DOWNERS ROCK SUBDIVISION

APPLICATION NUMBER 1 DATE January 18, 2018

REQUEST Subdivision

DETAIL SITE PLAN

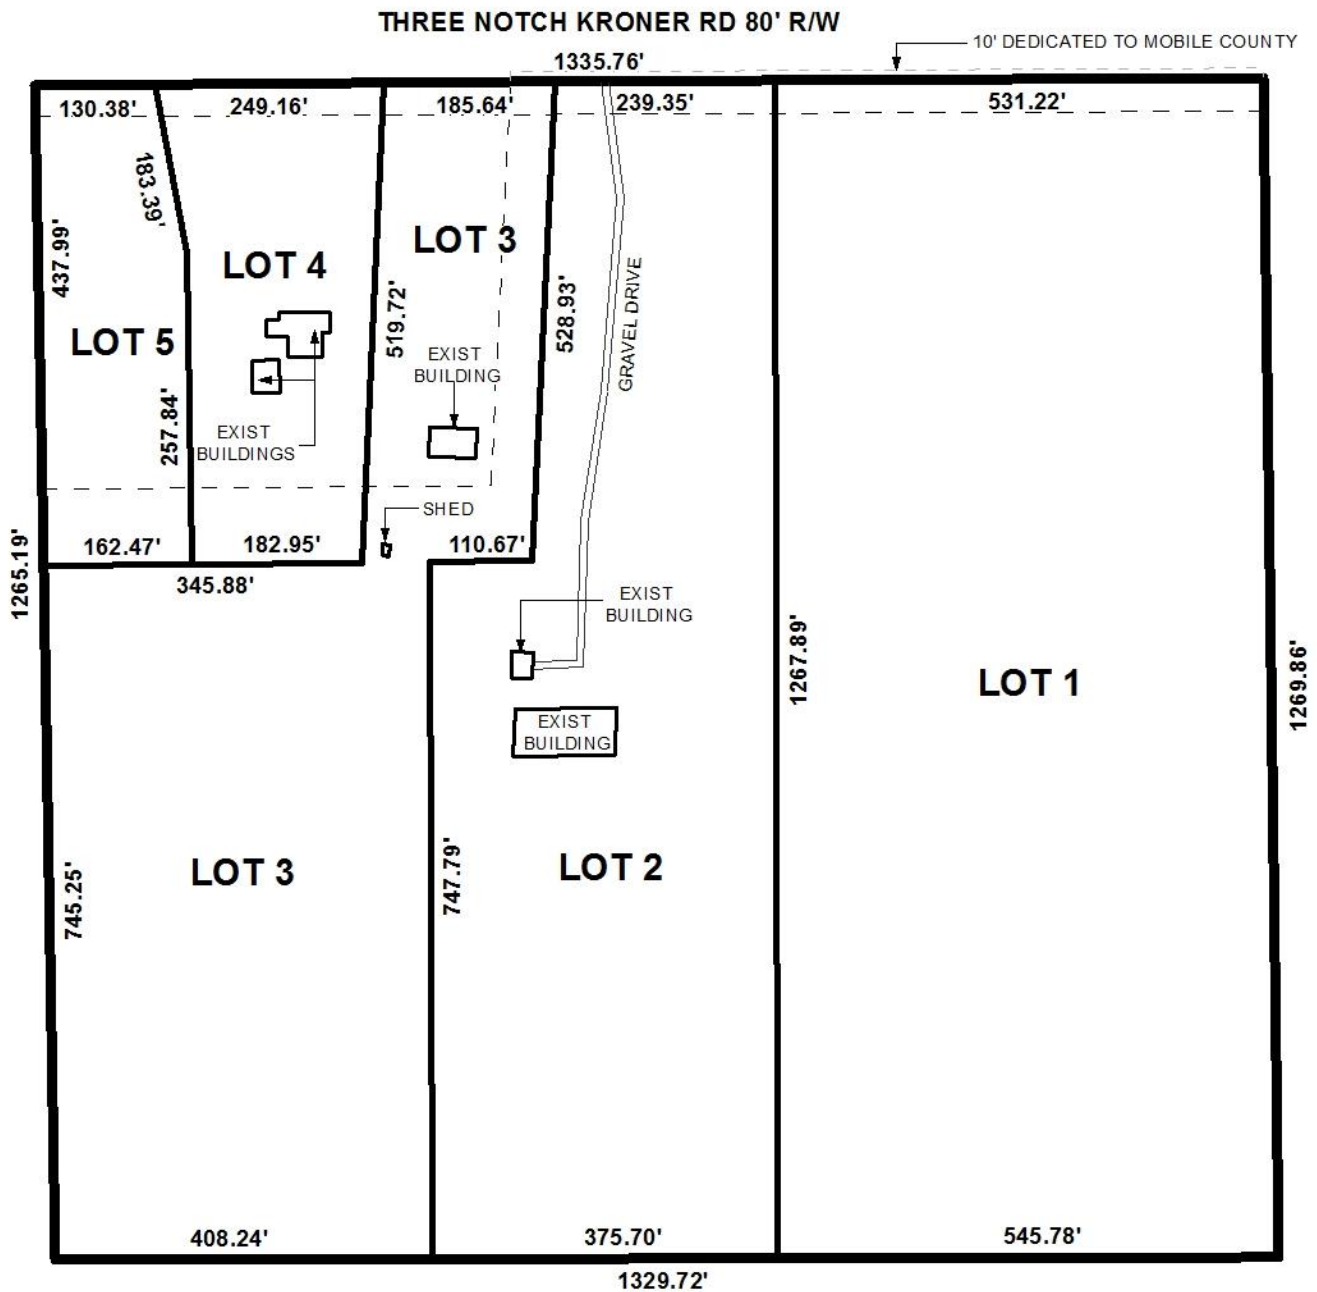
Each lot number is depicted, and meets the minimum lot size requirements and is labeled in square feet and acres. However, Lots 2 and 3 appear to exceed the recommended width to depth ratio of the Subdivision Regulations. Thus, a waiver of Sections V.D.1. and V.D.3. of the Subdivision Regulations will be required, if approved. Lot 3 is also labeled twice on the plat. The plat should be revised to remove one of the "Lot 3" labels.

Lot 3 is oddly shaped, and there is a concern that an attempt could be made to further subdivide Lot3. While Lot 3 has 185 ± feet of frontage, the front 2.2 ± acres of the lot are nearly separated

from the remaining 7.1 ± acres by a 70± foot wide constriction of the lot. As such, no future subdivision should be allowed until additional frontage is provided to an improved street frontage.

The revised plat depicts a 35' minimum building setback line. The 35' minimum building setback line should be retained on the Final Plat, if approved.

As a means of access management, a note should be placed on the Final Plat stating that Lot 1 is limited to 2 curb-cuts to Three Notch Kroner Road and Lots 2 through 5 are limited to one curb-cut each to Three Notch Kroner Road, with any changes to the size, design and location of the curb-cuts to be approved by Mobile County Engineering and conform to AASHTO standards.

Based on the preceding, and with a waiver of Sections V.D.1. and V.D.3. of the Subdivision Regulations, the application is recommended for Tentative Approval, subject to the following conditions:

- 1. placement of a note on the Final Plat stating that there shall be no future subdivision of Lot 3 until additional frontage is provided to an improved street frontage;*

- 2. removal of one of the "Lot 3" labels on the plat;*
- 3. retention of the 35' minimum building setback lines;*
- 4. dedication to provide 50' from centerline of Three Notch Korner, as depicted;*

- 5. placement of a note on the Final Plat stating that Lot 1 is limited to 2 curb-cuts to Three Notch Road and Lots 2 through 5 are limited to one curb-cut each to Three Notch Kroner Road, with any changes to the size, design and location of the curb-cuts to be approved by Mobile County Engineering and conform to AASHTO standards;*

- 6. placement of a note on the Final Plat stating that any lots which are developed commercially and adjoin residentially developed property must provide a buffer, in compliance with Section V.A.8. of the Subdivision Regulations;*
